RIDGE PORT NORTH 5TH ADDITION

WICHITA, SEDGWICK COUNTY, KANSAS

RE: SUB 2002-53 -- One-Step Final Plat of Ridge Port North Fifth Addition

CASE NUMBER: SUB 2002-53 -- RIDGE PORT NORTH FIFTH ADDITION

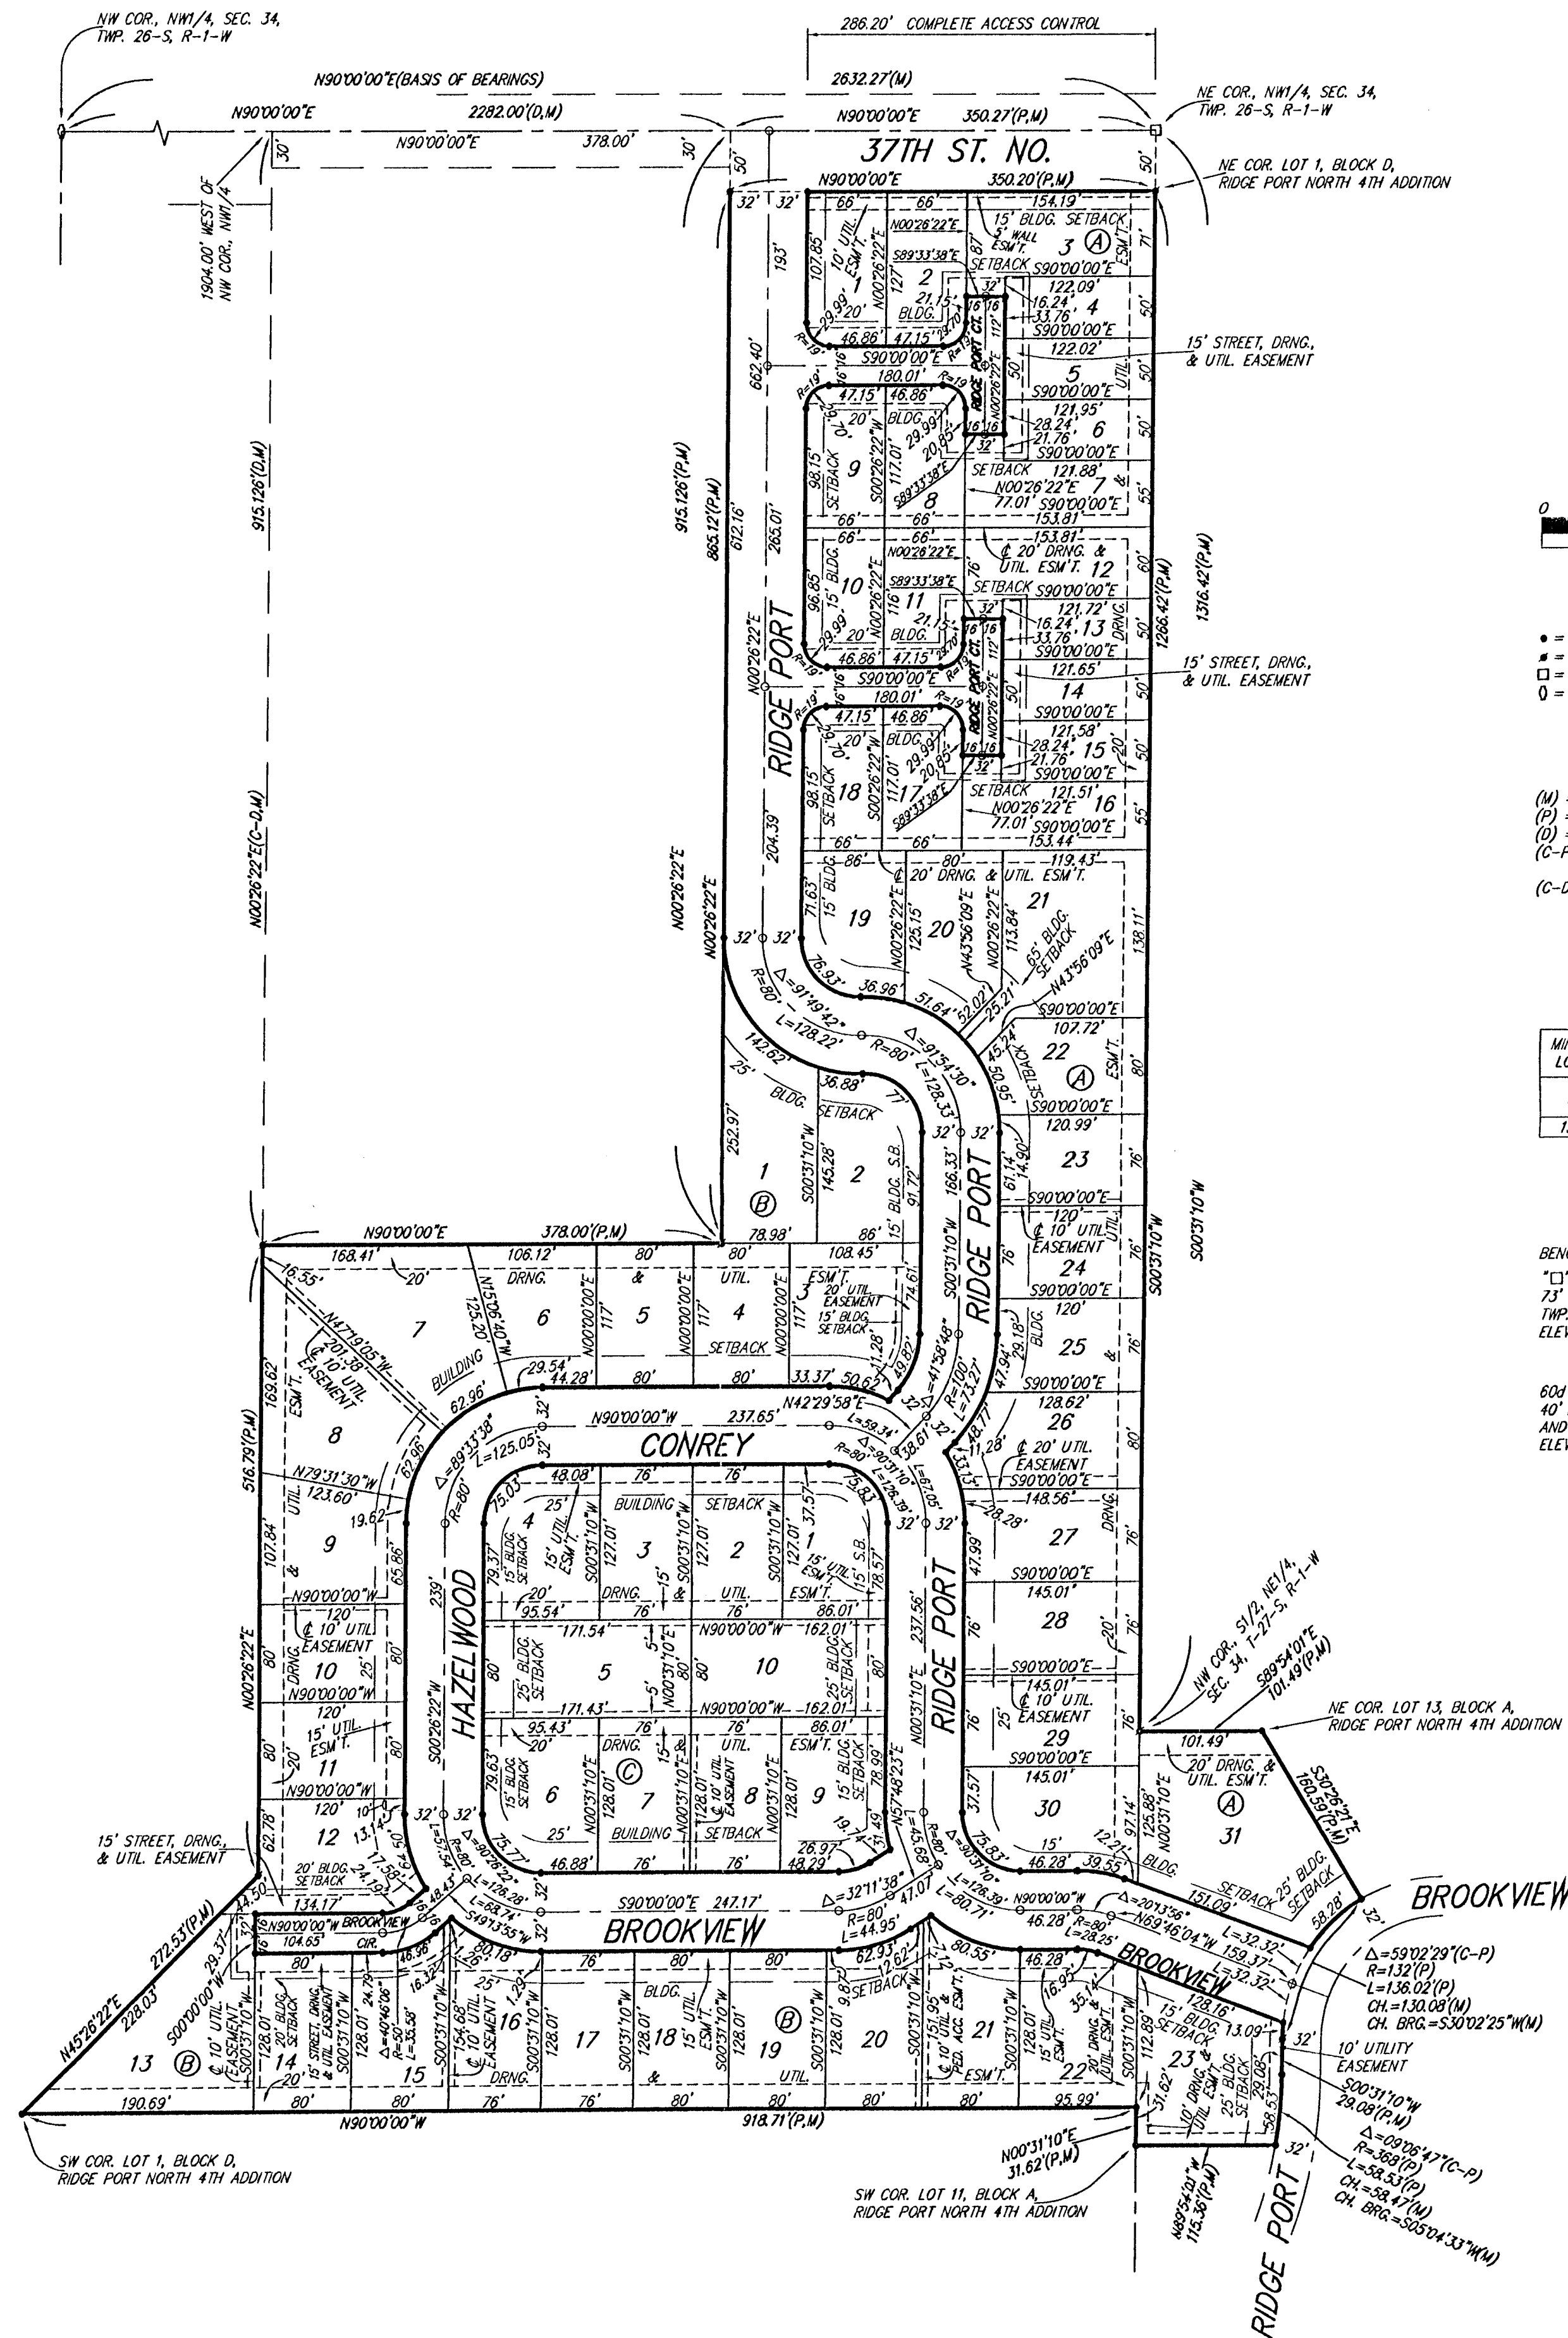
- A. The applicant shall guarantee the extension of sanitary sewer and City water to serve the lots being platted, including a water supply line along the frontage of 37th St. . City Engineering needs to comment on the need for other guarantees or easements. The required 15-ft street drainage and utility easements abutting the 32-ft streets need to be labeled.

- D. City Engineering needs to comment on the status of the applicant's drainage plan. County Engineering has requested a drainage plan for review.
- E. The applicant shall guarantee the paving of the proposed interior streets. For the narrow public 32-foot streets, this guarantee shall be for the 29-foot paving standard. The guarantee shall also provide for sidewalks on at least one side of all through, non cul-de-sac streets.

- H. City Fire Department needs to comment on the turnarounds platted for the 32-ft streets. The turnarounds are approved.
- I. City Fire Department/GIS needs to comment on the street names. 36th St. N. needs to be renamed. Brookview Ct shall be renamed as Brookview Cir.

- J. Since this plat proposes the platting of narrow street right-of-way with adjacent "15-foot street drainage and utility easements", a restrictive covenant shall be submitted which calls out restrictions for lot-owner use of these easements. Retaining walls and change of grade shall be prohibited within these easements as well as fences, earth berms and mass plantings.

- M. Lot 21, Block A does not conform with the 50-ft lot width standard which is measured at the building setback line. An increase in the distance of the building setback from the road would meet the standard.

- P. The platting text shall include language that a drainage plan has been developed for the plat and that all drainage easements, rights-of-way, or reserves shall remain at established grades or as modified with the approval of the applicable City or County Engineer, and unobstructed to allow for the conveyance of stormwater.
